Sensitivity Differences When Migrating from QT100 to QT100A

The QT100A is designed to replace the QT100 with almost identical electrical characteristics. The sensitivity of the two devices is virtually identical in certain voltage ranges but may require a change of the Cs capacitor outside this range. This Application Note will help guide you in determining whether to be concerned about any potential changes and if so, how to go about making the QT100A more similar in behavior to the QT100. This Application note will also be applicable to the QT102A upon its release.

Figure 1: Sensitivity performance of QT100 and QT100A vs V_{dd} , with $C_s=10nF$ and $C_x=5pF$. Higher values mean less sensitivity. Sensitivity differences are imperceptible in the range of $V_{dd} = 2.0V \sim 3.5V$.

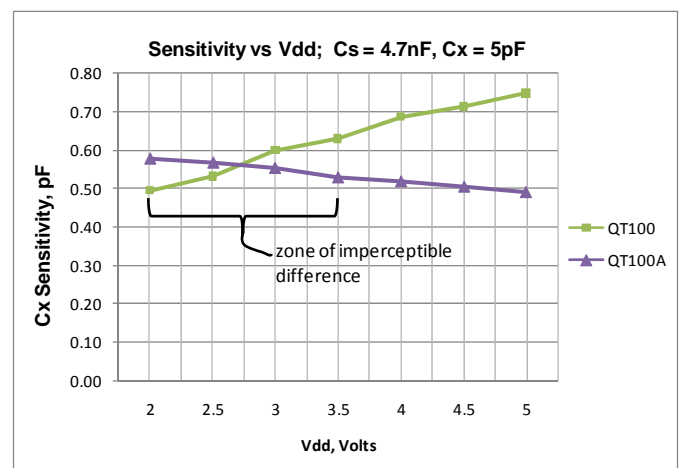
Figure 1 shows the sensitivity plots for the QT100 and QT100A in a circuit where the capacitive loading on the SNS pins (due to trace wiring and the sensing electrode capacitance) is 5pF and the Cs capacitor is set to 10nF (0.01uF) for both devices. Most touch sensors are designed to trigger on Cx changes in the range of 0.25pF to 1pF; the values shown in Figure 1 are at the more sensitive end of this range.

As can be seen there is a crossover point at $V_{dd}=2.75$ where the sensitivities of the two parts are identical. Due to the fact that human perception of sensitivity is extremely coarse (a 20% variance before sensitivity is barely noticed), and the fact that the QT100A becomes more sensitive with increasing V_{dd} , there is a 'safe zone' centering around 2.75 volts where the two parts are perceptually identical.

Above $V_{dd}=2.75$, the QT100A becomes more sensitive than the QT100; it is very difficult for most people to notice this effect until $V_{dd}=4V$. When replacing the QT100 with the QT100A at these elevated voltages, the worst that can happen is that the touch button becomes slightly *more* sensitive, which of course is far better than becoming *less* sensitive.

Figure 2: Sensitivity performance comparison with $C_s=4.7nF$ and $C_x=5pF$. Once again, sensitivity differences are imperceptible in the range of $V_{dd} = 2.0V \sim 3.5V$.

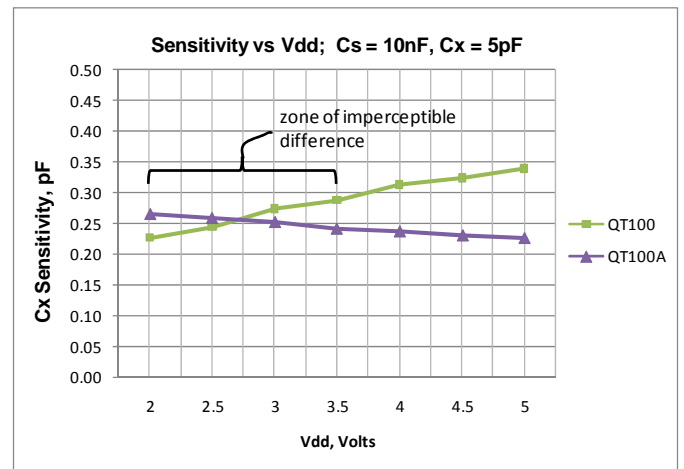
Figure 2 shows the same type of plot but with a lower Cs capacitor value (4.7nF) and therefore, lower overall sensitivity compared to Figure 1. Once again, the 'safe zone' ranges from Vdd=2.0 to Vdd=3.5V.
